**SPECIAL MEETING OF COUNCIL**

**9 MARCH 2020**

- PROPOSED SERVICE COMMERCIAL STRUCTURE PLAN - LOT 3082 CABLE BEACH ROAD EAST

### 7.1.1 PROPOSED SERVICE COMMERCIAL STRUCTURE PLAN - LOT 3082 CABLE BEACH ROAD EAST

Figure 9: Existing and Future Retail and Commercial Areas – Broome townsite

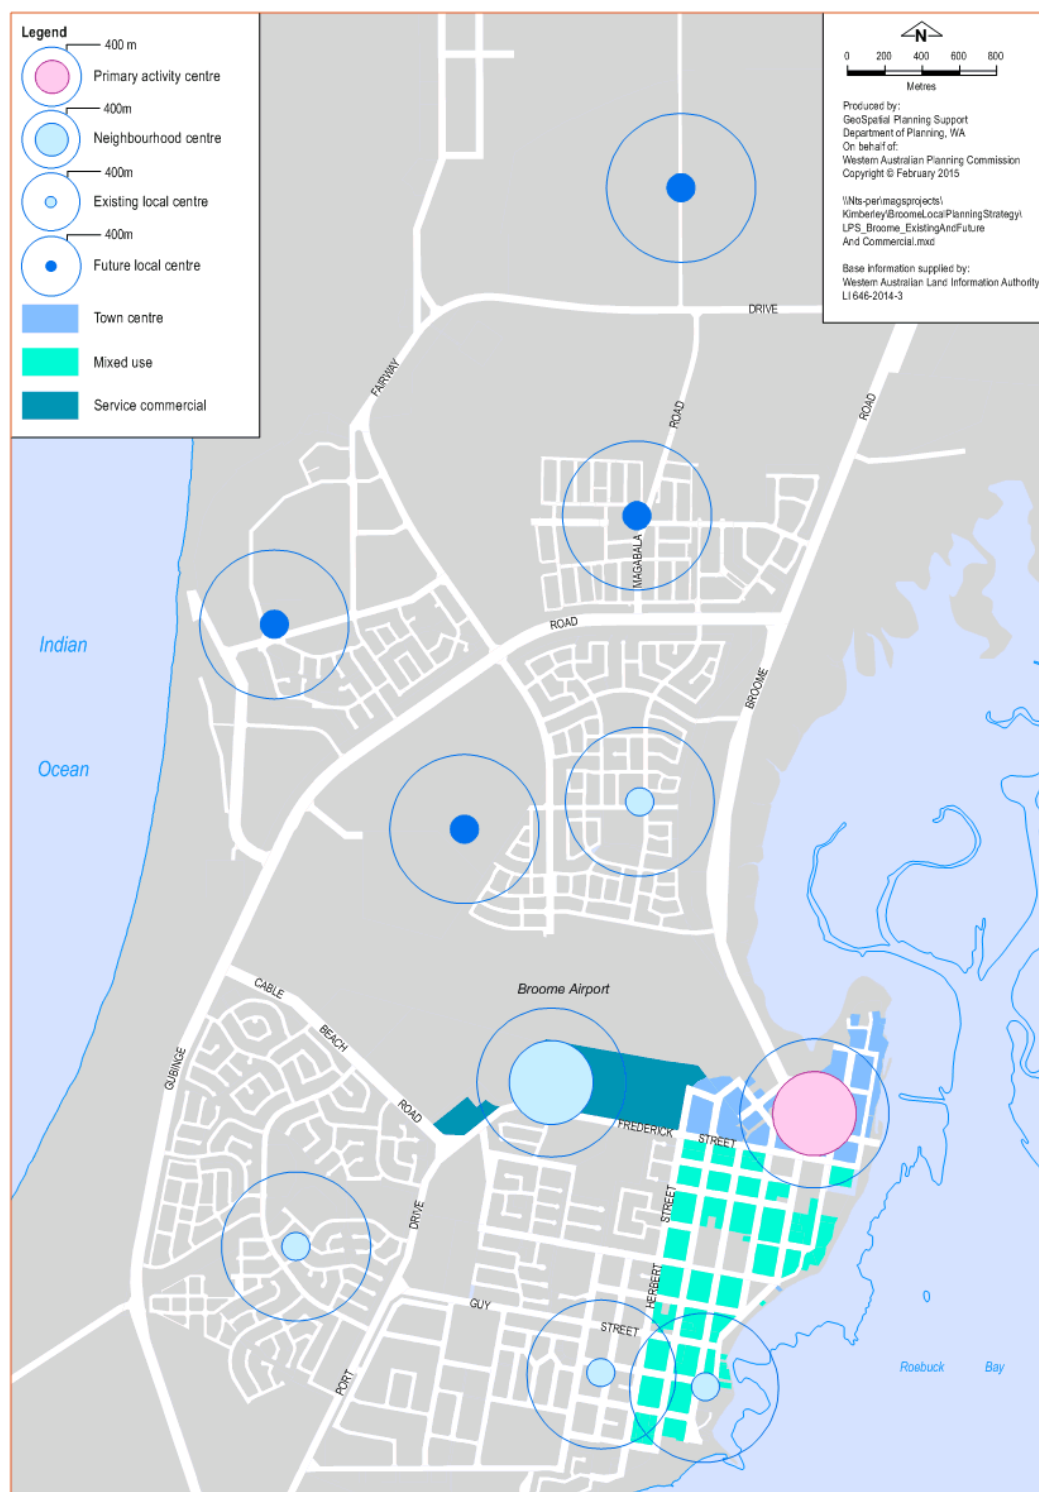
In this regard, the development of a service commercial precinct on the subject site is not considered appropriate as it does not provide a logical nor preferred location for this type of land use. Figure 9 of the LPS (**Attachment No 3**), demonstrates a rational pattern of commercial development throughout the townsite of Broome, which was reviewed through the adoption of LCS17. The identification of the service commercial area on Frederick Street acts as a natural extension of commercial activity which transitions from the primary and traditional town centre being Chinatown, to the existing commercial uses along Fredrick Street, through to the Boulevard and concluding at the intersection of Cable Beach Road East and Fredrick Street. To leap-frog this area and develop at the subject site, would fragment what is a logical extension of commercial activity and create another independent commercial area in Broome, which is not consistent with good planning practice.

Figure 2: Spatial Representation of Bushfire Management Plan and Actions - Stage One.

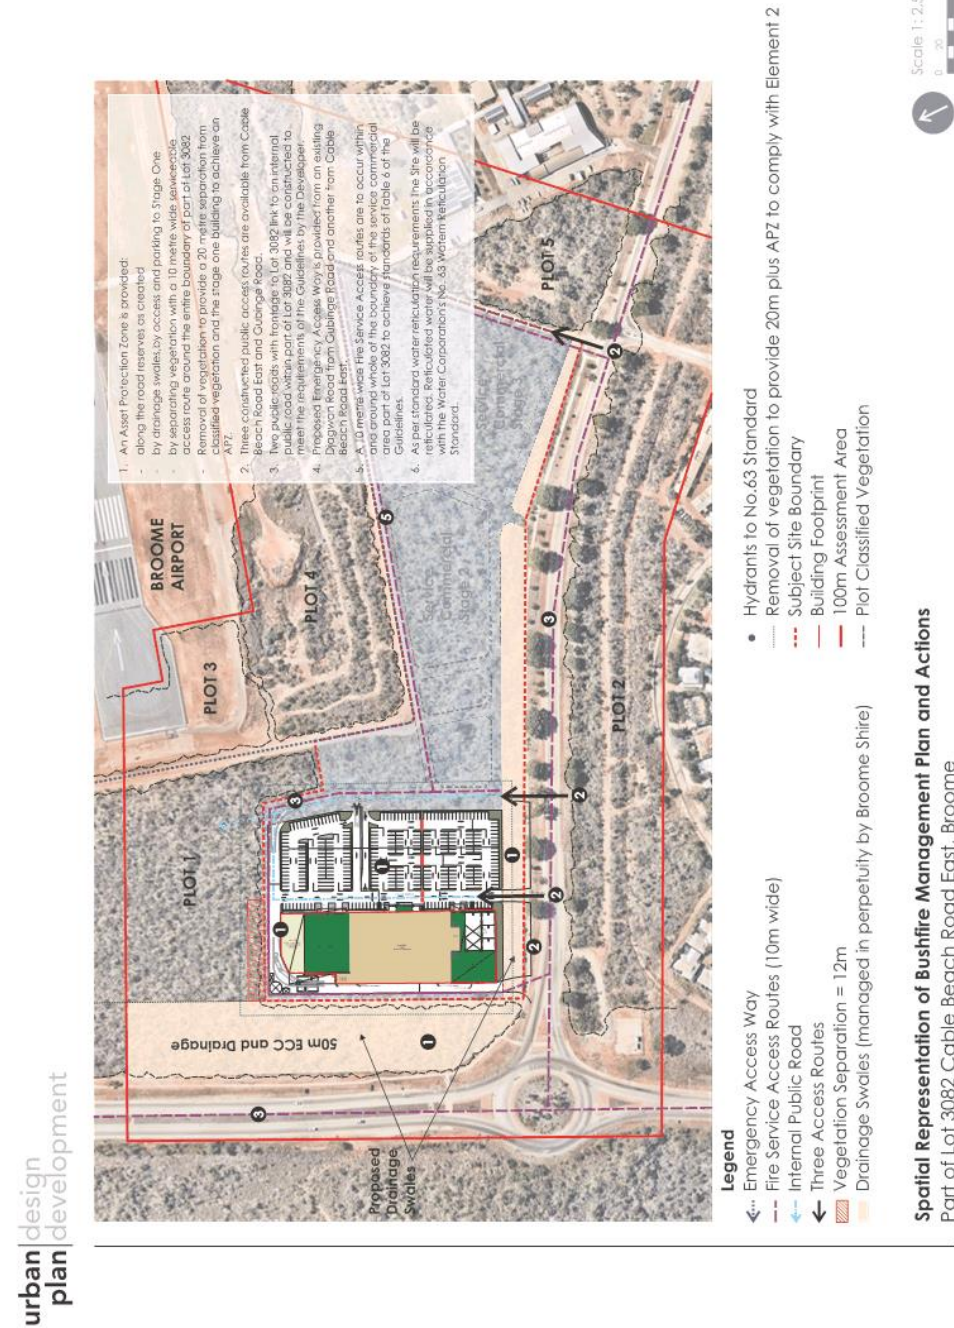
<p><b>Assessment</b> Figure 2 of the BMP depicts areas outside the site boundary as indicative APZ's. Bushfire management strategies should be achievable within the subject lot boundary. There is no mechanism to enforce clearing and maintenance of the vegetation within the adjoining areas in perpetuity.</p> <p><b>Action</b> Modification required.</p> <p>d) <b>Issue</b> BAL Contour Map input</p> <p><b>Assessment</b> The indicative BAL ratings cannot be validated. The inputs (i.e. slope/actual separation distances/vegetation classification) need to be included in the BMP to demonstrate the methodology applied to determine the BAL outputs within the Contour Map. This would generally be provided in a table. The BAL contours should extend from all areas of classified vegetation.</p> <p><b>Action</b> Modification required</p> <p>Policy Measure 6.3 c) Non-compliance with the bushfire protection criteria</p> <p>e) <b>Issue</b> Location &amp; Siting and Design</p> <p><b>Assessment</b> A1.1 &amp; A2.1 – not demonstrated The BAL ratings applied cannot be validated as described in the table above.</p> <p><b>Action</b> Modification to the BMP required.</p> <p>f) <b>Issue</b> Vehicular Access</p> <p><b>Assessment</b> A3.1 – Two access routes The Policy requires that two vehicular access routes are provided, both of which connect to the public road network, providing safe access and egress to two different destinations. The BMP identifies that the subject site has access to Cable Beach Road East, which provides a connection to two different destinations, which demonstrates compliance with A3.1. Therefore, it is unclear why the BMP and referral documentation refers to both an Emergency Access Way and a Fire Service Access Route (FSAR).</p> <p><b>Action</b> Comment.</p> <p>g) <b>Recommendation</b> – not supported modification required</p> <p>The BMP does not adequately address the policy requirements of SPP 3.7 and the Guidelines.</p> <p>DFES has assessed the structure plan and accompanying BMP and has identified several issues that need to be addressed prior to support of the proposal (refer to the tables above).</p>

3.	Vegetation Management		<p>Figure 2 of the BMP depicts areas outside the site boundary as indicative APZ's. Bushfire management strategies should be achievable within the subject lot</p>	BMP to be updated to address DFES comments.

Figure 2: Lot Swale Diagram

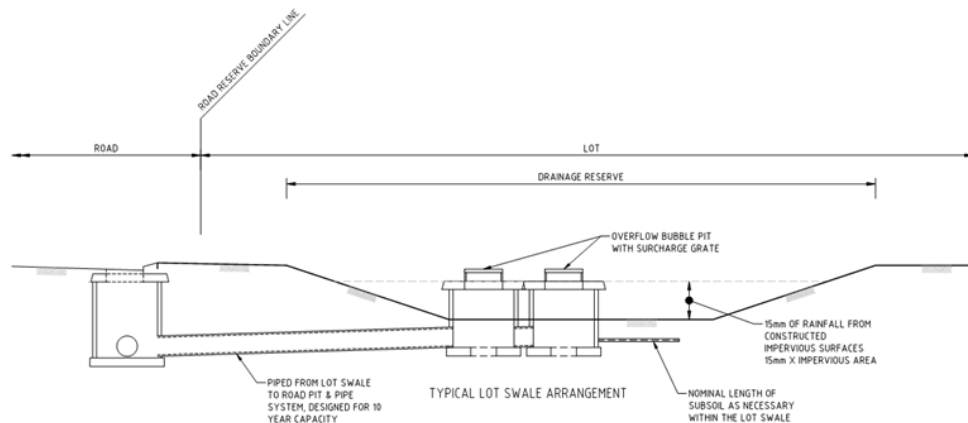
9.	LWMS - Figure 2 (page 11, figure 2)		Clarify whether figure 2 can be improved by avoiding overflow bubble up pit, and pit and pipe drainage system of road reserve. Lot swale can be designed just enough to manage runoff generated by small rainfall event. Provision can be made to have overland flowpath/sheet flow of runoff from lot swale to road side swale for the event greater than small rainfall event (page 11, figure 2).	LWMS to be updated to reflect DWER comments.
